**To:** Simon Lee, The California Energy Commission.

**From:** Ella Sung, Rish Ghatikar, Mary Ann Piette, and Norm Bourassa; Lawrence Berkeley National Laboratory

**Date:** February 9, 2015

**Re:** Recommended Improvements for 2016 California Title 24 Building Codes

**Figure:** Mapping Physical and Logical Interfaces for Demand Response Signals  
(Ghatikar et al. 2015)

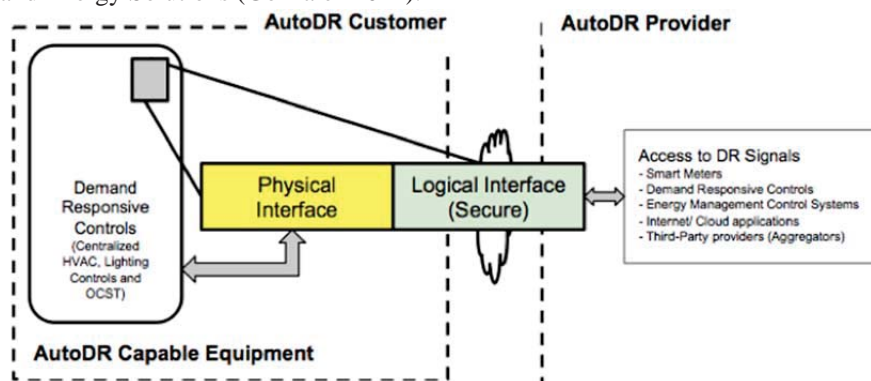
- More technical detail should be added in the code language using diagrams and/or more specific terms and explanations on how demand-responsive controls (or AutoDR capable equipment) can receive and respond to the AutoDR signals from an external provider, including links to the physical and the logical interfaces. The below figure shows an example of such detail. There are additional illustrations in the published documents from Southern California Edison (Energy Design Resources 2014) and Energy Solutions (Gonzalez 2014).
